Where is the mass that has velocity zero?

Dear reviewers, editor and interested readers,

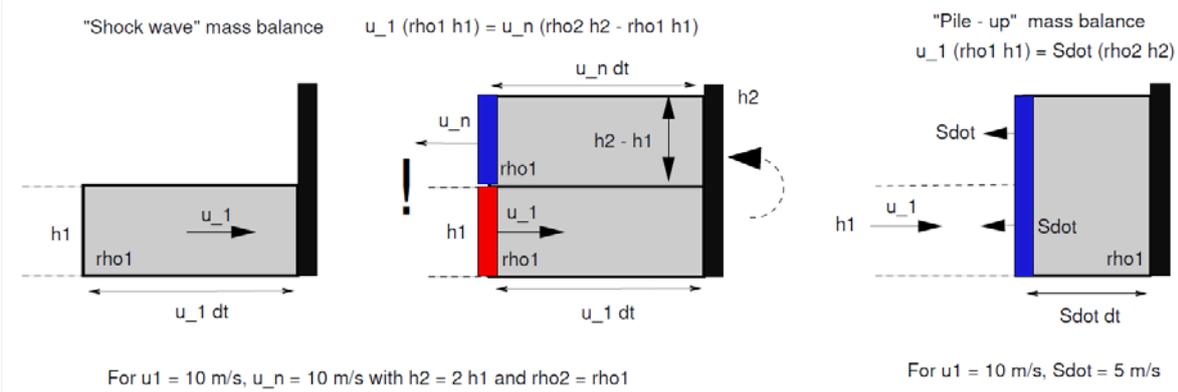
Consider the first time interval dt when an avalanche with height h_1 hits the wall. Consider further that in this case the pile-up height doubles $h_2 = 2 h_1$, but there is no compaction, $\rho_2 = \rho_1$. This is shown in the figure 1 below. For this case, the “shock” wave model predicts that the out-going “wave” speed is equal to the incoming speed of the avalanche $u_n = u_1$. Thus, for the interval dt ,

the distance that the “shock” travels back ($u_n dt$) is equal to the length the incoming mass travels towards the wall ($u_1 dt$). Moreover, the avalanche hits the wall, and then is immediately deflected, traveling “on top” of the incoming avalanche. A shear plane must therefore develop in the pile-up zone and the “shock” front breaks down. In fact, there is no pile-up, only a deflection of mass. Moreover, the starting assumption of the shockwave model (a “shockwave” of height h_2 propagates backward) is violated. It simply cannot happen with $u_n = u_1$. With our calculated speed S_{dot} , the pile-up wave extends over the entire height h_2 . The entire mass ($u_1 h_1 \rho_1$) is stopped in front of the wall. We ask a simple question: where is the mass with zero velocity? Where is the pile-up? For us, it is in front of the wall.

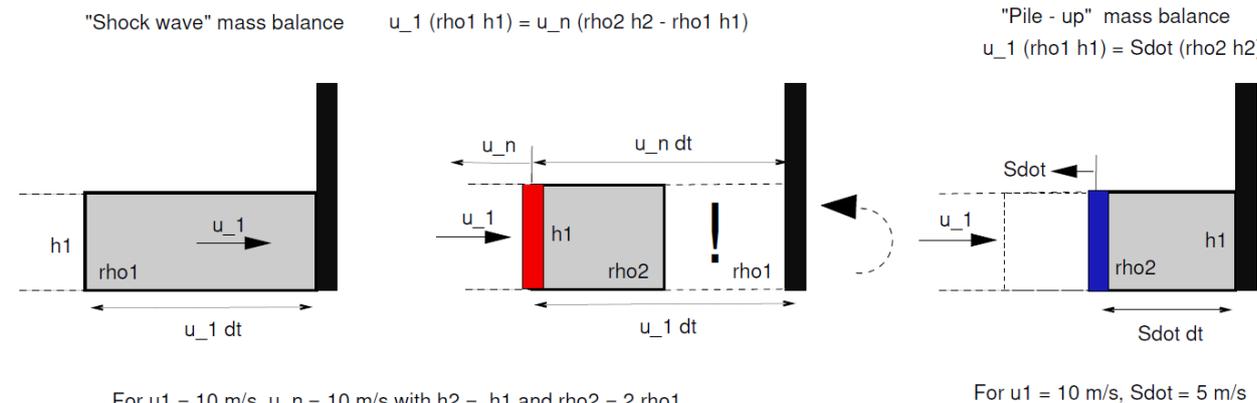
Another example serves to demonstrate why the shockwave approach is not suitable to model a pile-up and therefore avalanche impact pressures. Consider the case where the height of the incoming and piled-up mass are equal $h_2 = h_1$. The avalanche snow, however, compacts to twice the incoming density $\rho_2 = 2 \rho_1$. Again the speed of the “shock” (according to Thierry Faug) is given by $u_n = u_1$. This case is shown in Figure 2.

The results from the “shockwave” approach are simply bizarre. The avalanche mass hits the wall and propagates backwards with the density ρ_2 to the location $u_1 dt$ (the end location of the incoming mass). Moreover the speed of the incoming mass is equal to the “shock” speed $u_n = u_1$. However, the outgoing mass is compacted (the density behind the shock has increased). Therefore, the length of the compacted mass must be reduced because the height remains the same. Thus, it appears that an empty space develops between the outgoing mass and the wall. The empty space, however, is, according to the shockwave model, filled with the mass, $u_n \rho_1 h_1$. This is incredible: mass must travel through the outgoing wave (or perhaps it simply jumps over it) and piles-up with the density ρ_1 in front of the wall! This is simply not our picture (or any suitable mathematical characterization) of snow pile-up. For us, this completely erroneous result is a direct consequence of subtracting the amount $u_n \rho_1 h_1$ from $u_n \rho_2 h_2$ in the mass balance equation. This is the term that Thierry Faug wants us to be included in our mass balance. What is the physical reason for this inclusion? Simply because it agrees with a “shockwave” model? Again, we ask the question: where is the mass with zero velocity?
